CITY OF FREDERICKSBURG HISTORIC REVIEW BOARD

TUESDAY, AUGUST 17, 2021

7. CERTIFICATE OF APPROPRIATENESS APPLICATIONS

SITE PLAN
SCALE: 1/8" = 1'-0"

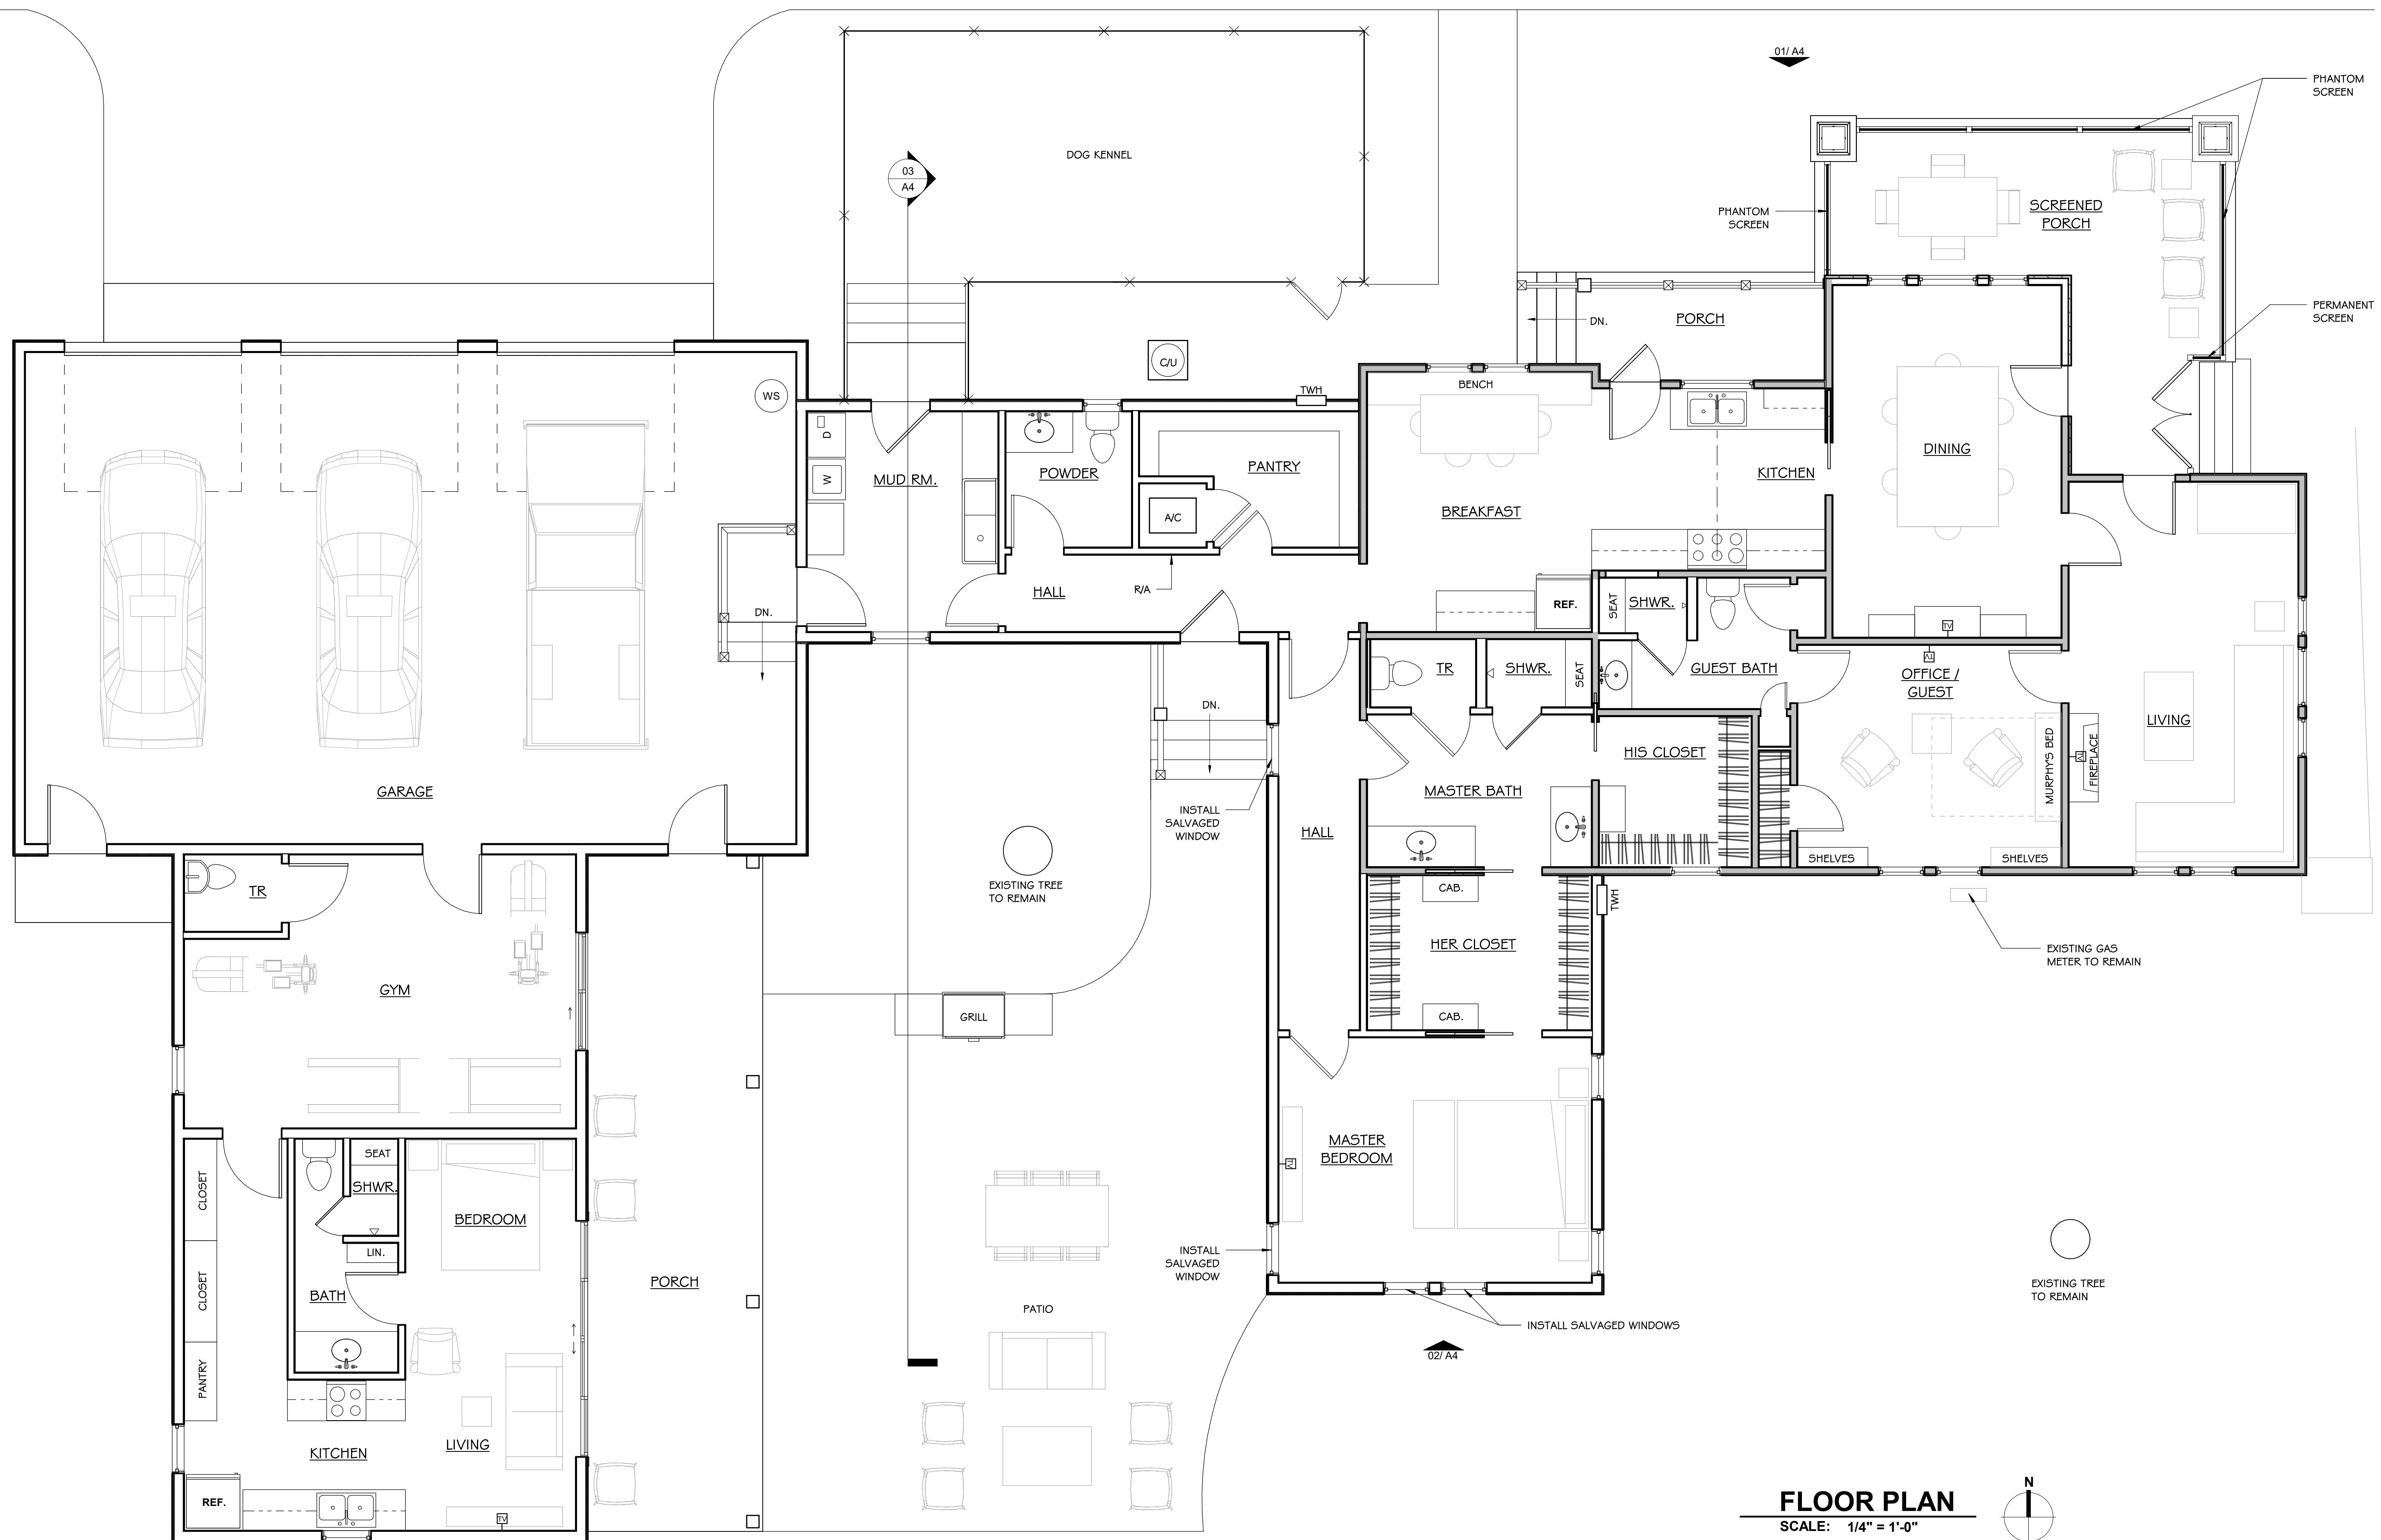
1. Diminishing the historical integrity of the building with the new additions.
2. Destroying significant features or detail during the construction process.
3. Altering the original facade, roof line, or setback of the original building.

Figure 3-31. Illustrations depicting **inappropriate** types of window replacements, not matching the historic configuration or pattern of lites. Source: Winter & Company archives.

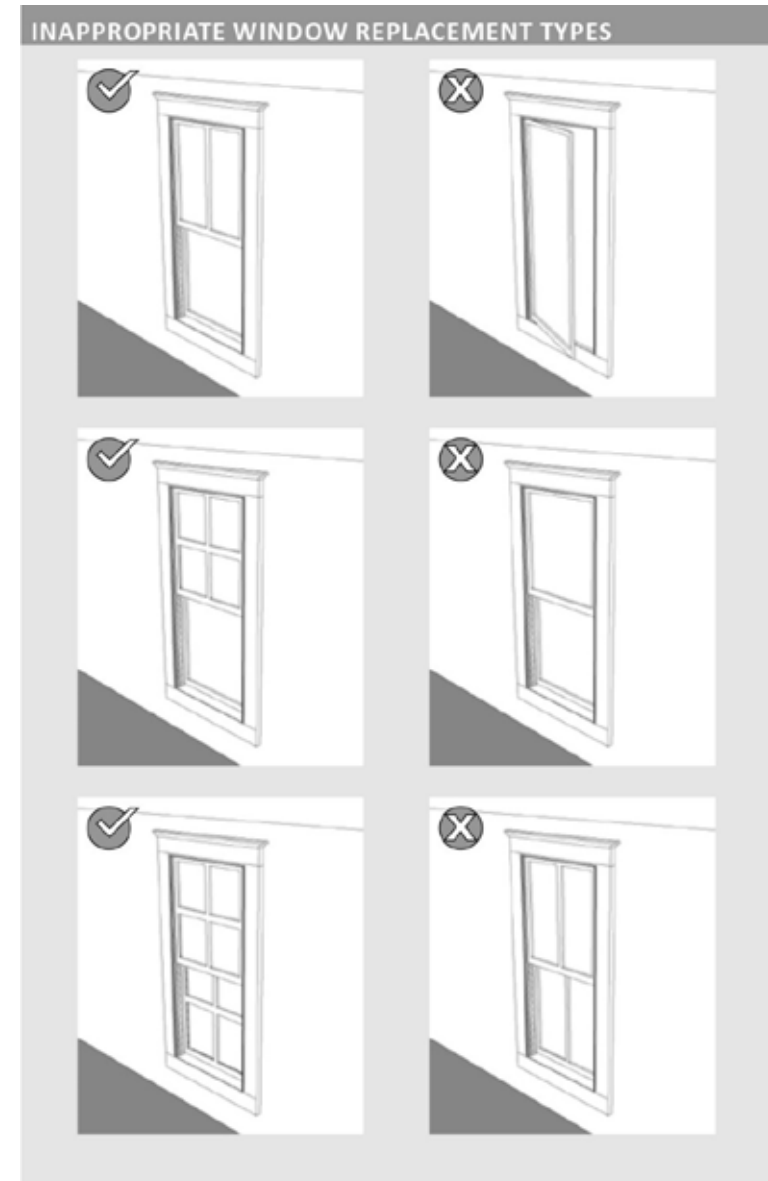
Staff does not recommend removal of the original windows. This recommendation is in keeping with SOI standard number #6 and FBG Design Guidelines for windows (included in packet).

FRONT PERSPECTIVE

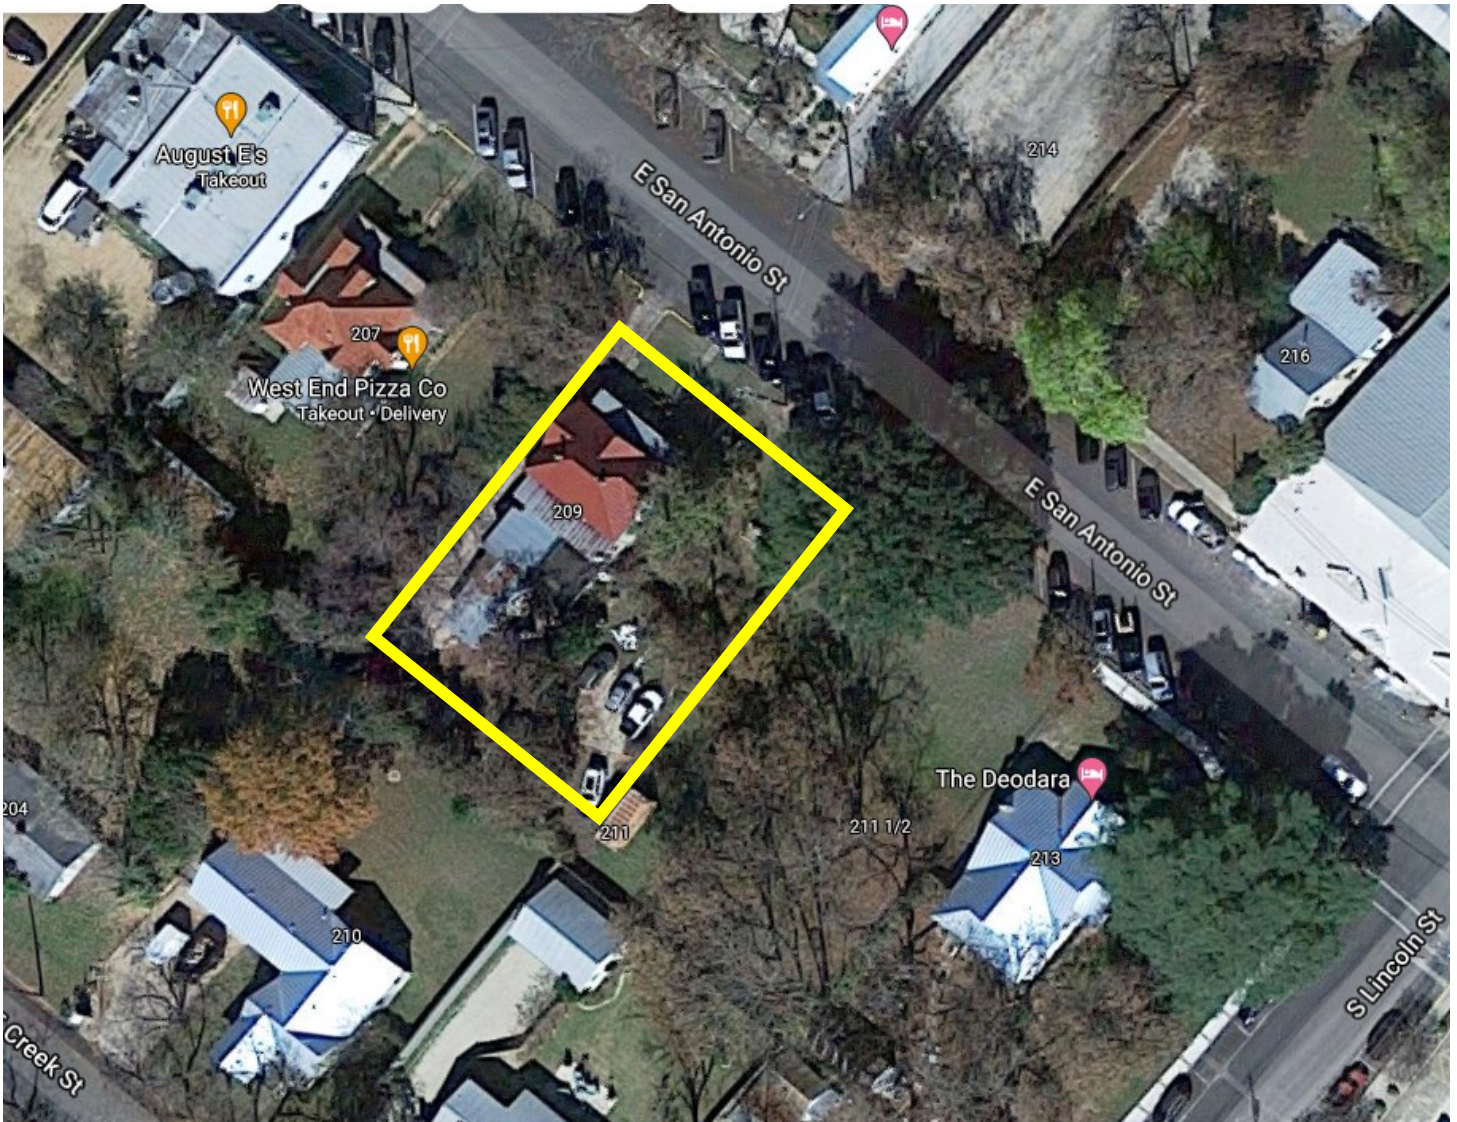
Staff recommends the new pergola/covered trellis is pulled back from the front façade. The height is compatible and the openness of the structure is a benefit. More detail is needed on how the pergola will abut the side of the house. As presented staff does not recommend approval based on Section 3.3 a, c and e.
